SUBJECT: Grand Gulf Nuclear Station  
Units 1 and 2  
Docket Nos. 50-416 and 50-417  
File 0260/0272/L-344.0  
Human Factors Engineering Review  
AECM-81/291

HUMAN FACTORS ENGINEERING  
CONTROL ROOM DESIGN REVIEW FINAL REPORT  
GRAND GULF NUCLEAR STATION  
MISSISSIPPI POWER AND LIGHT COMPANY

FIGURE 2: STATUS LIGHTS, PUSHBUTTONS AND  
REACTOR WATER LEVEL ANNUNCIATORS

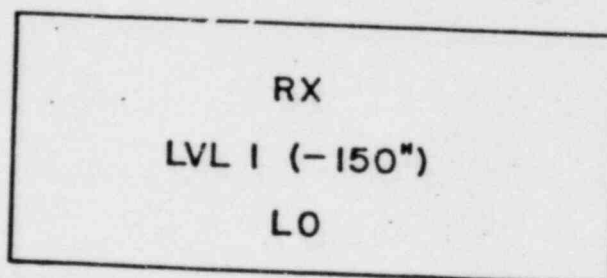
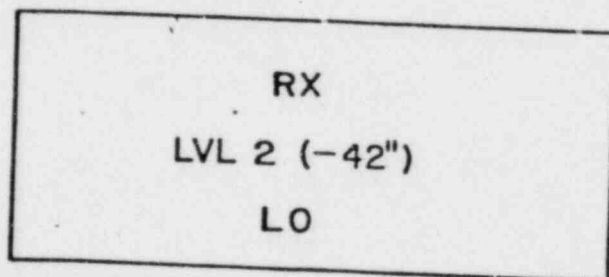
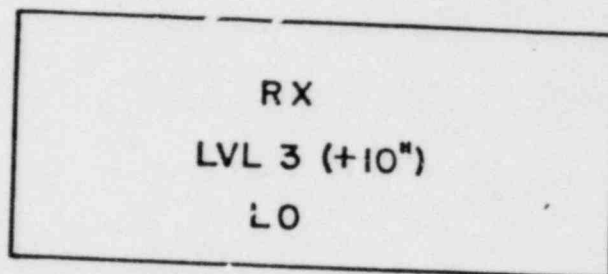
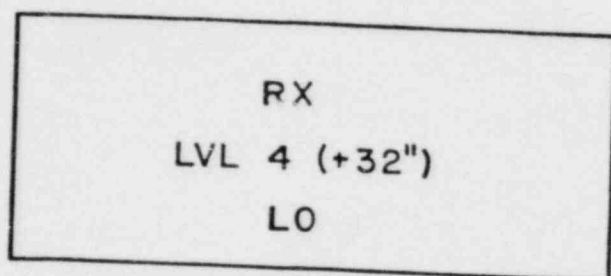
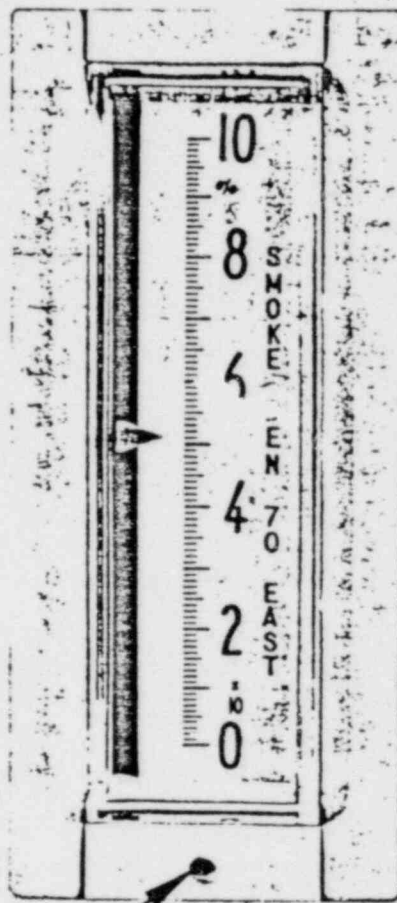
The annunciator tiles dealing with REACTOR LEVEL LOW will be revised as indicated in Figure 2 to reflect specific levels. This discrepancy will be corrected prior to loading fuel.

Provision will be incorporated to readily distinguish the pushbuttons from the status lights as indicated by figure 2. This discrepancy will be corrected prior to loading fuel.
